RECEIVED
By yfigueroa at 2:26 pm, Jun 30, 2023

Paramount Theater
139 N COUNTY RD
PALM BEACH, FL 33480

FINAL
SUBMISSION
06/30/2023

C-101

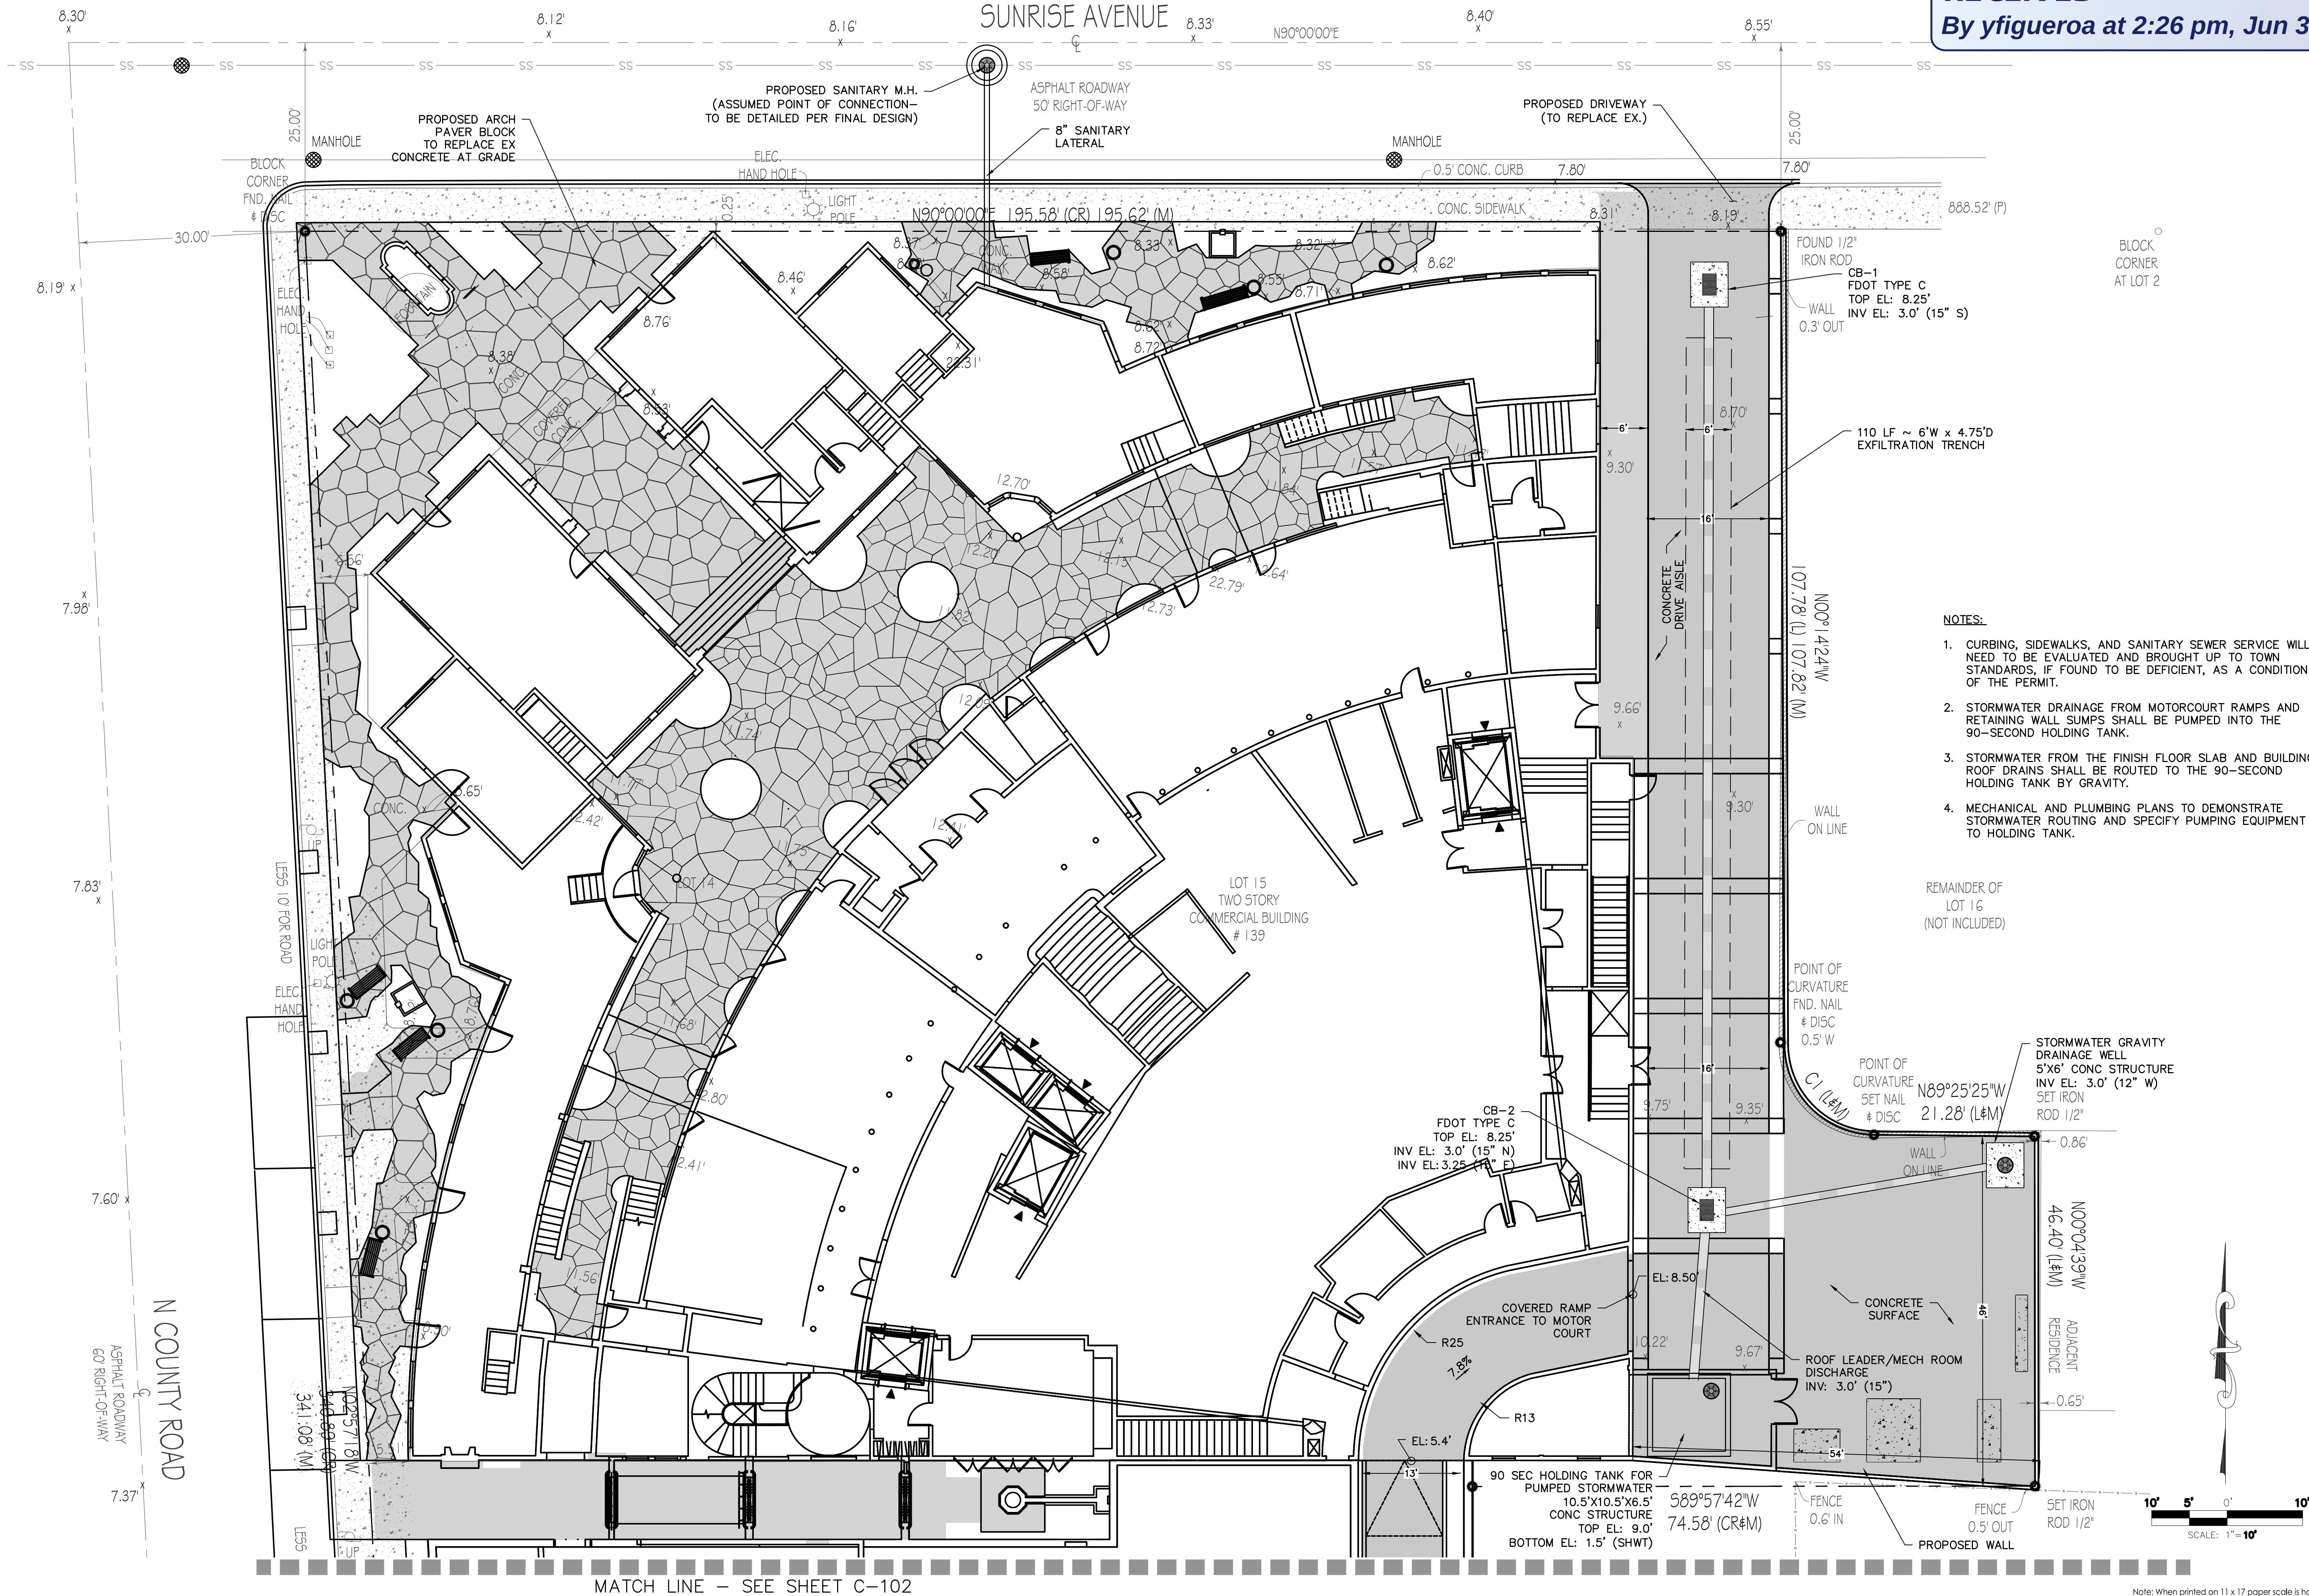
- NOTES:
1. CURBING, SIDEWALKS, AND SANITARY SEWER SERVICE WILL NEED TO BE EVALUATED AND BROUGHT UP TO TOWN STANDARDS, IF FOUND TO BE DEFICIENT, AS A CONDITION OF THE PERMIT.
 2. STORMWATER DRAINAGE FROM MOTORCOURT RAMPS AND RETAINING WALL SUMPS SHALL BE PUMPED INTO THE 90-SECOND HOLDING TANK.
 3. STORMWATER FROM THE FINISH FLOOR SLAB AND BUILDING ROOF DRAINS SHALL BE ROUTED TO THE 90-SECOND HOLDING TANK BY GRAVITY.
 4. MECHANICAL AND PLUMBING PLANS TO DEMONSTRATE STORMWATER ROUTING AND SPECIFY PUMPING EQUIPMENT TO HOLDING TANK.
